STAFF REPORT: MARCH 25, 2025 MEETING

APPLICATION NUMBER: HDC2025-00032

ADDRESS: 8101 ST. PAUL

SCOPE: INSTALL ALUMINUM SIDING AND TRIM

Dormers and Windows

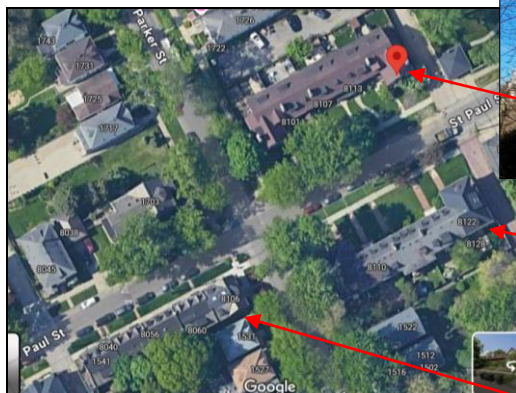
- Scrape paint
- Remove deteriorating wood from N dormer, W dormer, and 5 W wall windows
- Build and install custom window frames to receive aluminum siding for windows
- Add brown aluminum siding, flashing and sealant around N and W Dormer and all windows on W wall (2 singles and 1 triple window)
- Add aluminum siding to face of dormers

Left: Vinyl windows installed at 8107 St. Paul.

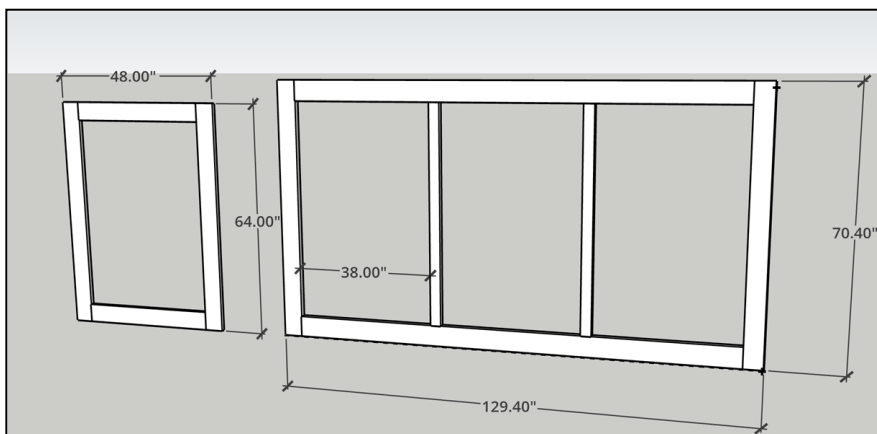
During staff's recent site visit, work completed at other units, such as vinyl windows and aluminum trim covering wood window casings, were identified on the facade. Staff did not find approvals on file for this work. The respective owners will be notified that their properties will receive violations and that applications for this completed work will need to be submitted for the Commission's review at an upcoming meeting.

Above: Applicant drawing of proposed window trim that will be wrapped in aluminum.

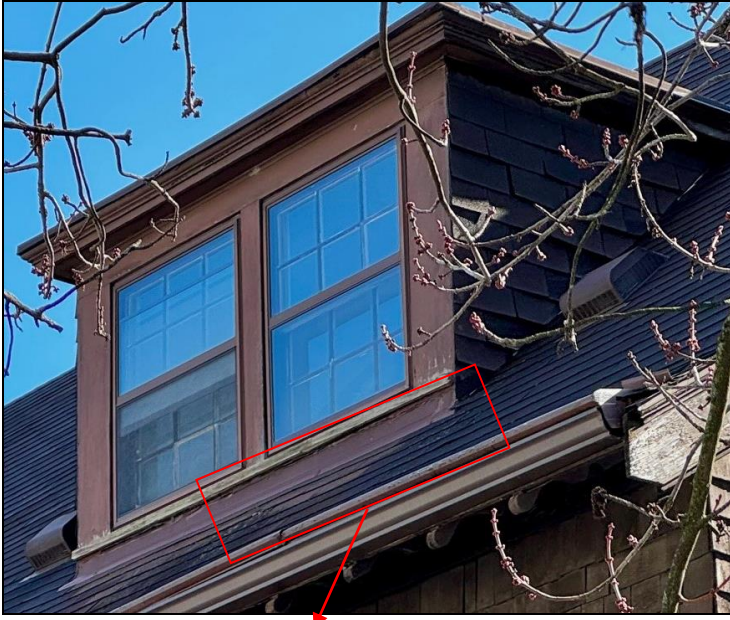
- The wood window casings are set within the stucco, and its removal may cause additional damage to the surrounding stucco finish, and staff expects the trim would need to be wider to compensate for the small areas where the existing horizontal trim extends beyond the vertical casings.

- The proposed wood trim is flat with square edges and doesn't match the details, dimensions and profiles of the historic wood trim.
 - Wrapping wood trim with aluminum emphasizes the flatness of a contemporary trim, as well as imparting a sheen which is incompatible with historic buildings.
